Access Compliance Report

Public Rights-of-Way

Intersection ID: N/A	Main Street: BROOKSVALE_ST	Cross Street: N/A	Location: NW
ADA ID: CB08FE83E0B8	Ramp Type: Perp	Initial Pass/Fail: Fail	Overall Compliance: No
		Severity Score: 1.25

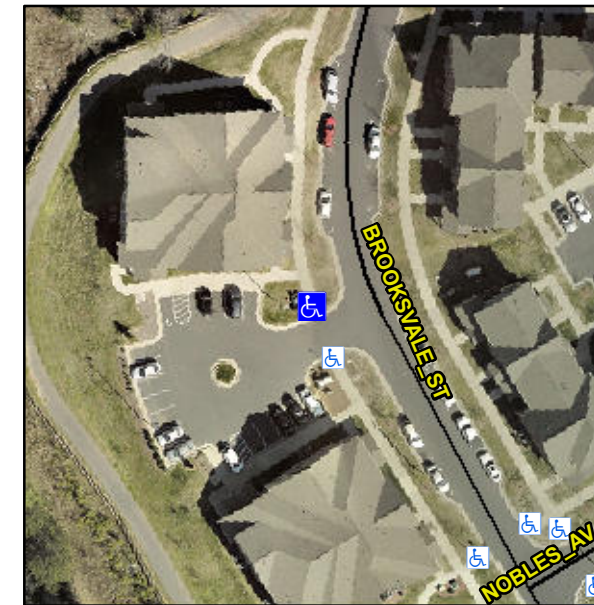
R304.5.3

Compliance	Description	Data	Compliance	Description	Data
N/A	Ramp Length (in)	73.0	Yes	Ramp Slope (%)	6.0
Yes	Ramp Width (in)	70.0	No	Ramp XSlope (%)	2.8
N/A	Flare Type LT	N/A	N/A	Flare Type RT	N/A
N/A	Flare Slope LT (%)	N/A	N/A	Flare Slope RT (%)	N/A
N/A	Flare Traversable LT?	N/A	N/A	Flare Traversable RT?	N/A
N/A	Landing Length (in)	N/A	N/A	DWS Provided?	N/A
N/A	Landing Width (in)	N/A	N/A	DWS Contrast?	N/A
N/A	Landing Slope (%)	N/A	N/A	DWS Length (in)	N/A
N/A	Landing X Slope (%)	N/A	N/A	DWS Full Width?	N/A
N/A	Landing Curb? (Y/N)	N/A	N/A	DWS Offset (in)	N/A
N/A	Shared Landing?	N/A			
N/A	Gutter Ponding?	N/A	N/A	Gutter Slope (%)	N/A
N/A	Gutter Lip Ht (in)	N/A	N/A	Gutter X Slope (%)	N/A
N/A	Painted X Walk1?	No	N/A	Painted X Walk2?	N/A
	X Walk 1 Direction	To S		X Walk 2 Direction	N/A
N/A	X Walk 1 Width (in)	N/A	N/A	X Walk 2 Width (in)	N/A
	X Walk 1 Slope (%)	2.3		X Walk 2 Slope (%)	N/A
	X Walk 1 X Slope (%)	0.8		X Walk 2 X Slope (%)	N/A

Remove & Replace Entire Ramp.
